LLNL-TR-420512

**LLNL's Response to 9/9/2009 Annual
Inspection Report Comments
B113 Issue #1 and B271 Issue #2**

Subject: *Lawrence Livermore National Laboratory (LLNL's) Response to 9/9/2009 Annual Inspection Report Comment – B113 Issue #1 and B271 Issue #2*

85100-1 FILL

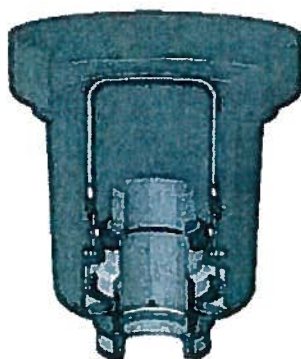
Issue #2: Provide specifications for the installation of a spill bucket of 5 gallon capacity on the fill riser within the pipe sump.

LLNL has prepared a UST Modification plan for the 271-D2U1 tank system to install a new 5 gallon spill bucket in the pipe sump. The enclosed UST Modification application includes the scope of the installation and the specification of the spill bucket that is proposed to be installed. After installation, the spill bucket will be leak tested and the leak test report will be sent to you.

Remove and dispose of existing fill adaptor and existing cap. Supply and install new Phil-Tite 5 gallon spill bucket with drain valve and factory installed internal riser (Part # 85100-1). Modify existing riser as needed or supply and install new riser if required. Remove and modify existing drop tube as needed and reinstall. Supply and install new fill adaptor and new cap. Modify/extend existing reducer collar as needed to clear new spill bucket when existing reducer collar cover is in place. After installation of new spill bucket, perform hydrostatic lake test or equivalent of new spill bucket to verify leak tightness. Provide spill bucket leak test report.
